AGENDA
PLANNING AND ZONING COMMISSION MEETING
CITY OF CREVE COEUR, MISSOURI
MONDAY, NOVEMBER 16, 2020

1. Application #20-032: Public Facility Site Development Plan Approval for a Building Addition and the Redevelopment of Spoede Elementary School at 425 N. Spoede Road

APPLICATION TO PLANNING AND ZONING COMMISSION
#20-032: PUBLIC FACILITY SITE DEVELOPMENT PLAN APPROVAL FOR A
BUILDING ADDITION AND THE REDEVELOPMENT OF
SPOEDE ELEMENTARY SCHOOL AT 425 N. SPOEDE ROAD

REVISED SITE PLAN PROPOSAL

Figure 20: Area for the trash enclosure the Paper Recycling from the revised site plan emailed on 10-29-2020

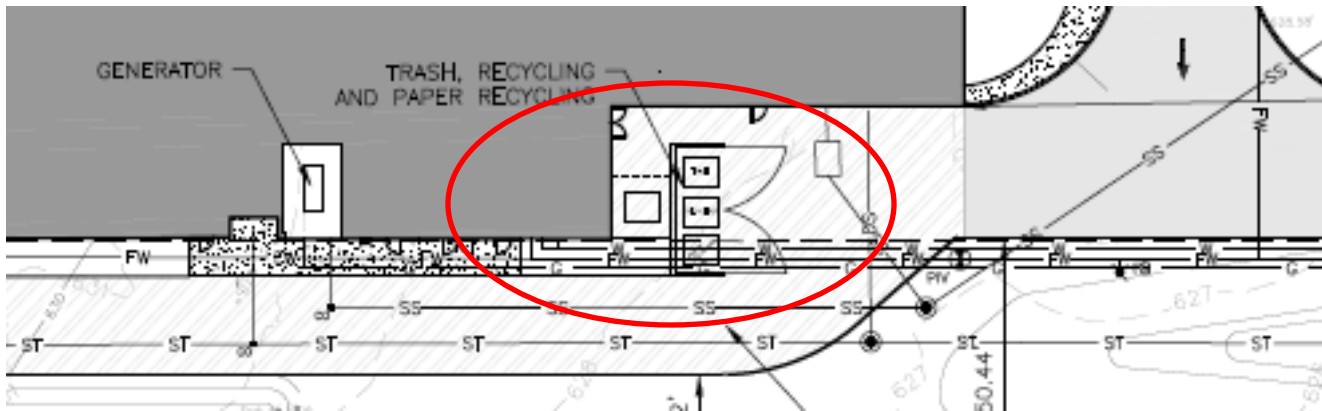
The Design Guidelines also recommend that services and trash or utility areas should be positioned to minimize view and visual impact. Building equipment and utilities are to be located, designed and/or screened to minimize visual impact on public streets, surface parking lots and neighboring properties. Accessory structures, with the exception of the front canopy, are to be behind the building line and if detached shall be a minimum of 10 feet from the principal structure, per Section 405.460(D) Location of Accessory Uses and Structures. If the trash enclosure is attached to the main building than it should comply with the requirements of the principal building. Details of the trash enclosures have not been provided, and it should be noted that the revised site plan emailed on October 29th shows the trash area to be at 45 feet within the building setback and buffer area. The rendering of the south entrance also shows that this area will be visible from Spoede Road. Therefore, Staff has included a condition that any trash and recycling dumpsters shall be located behind the front of the building and properly enclosed with brick materials consistent with the main building for the Zoning Administrator's approval.
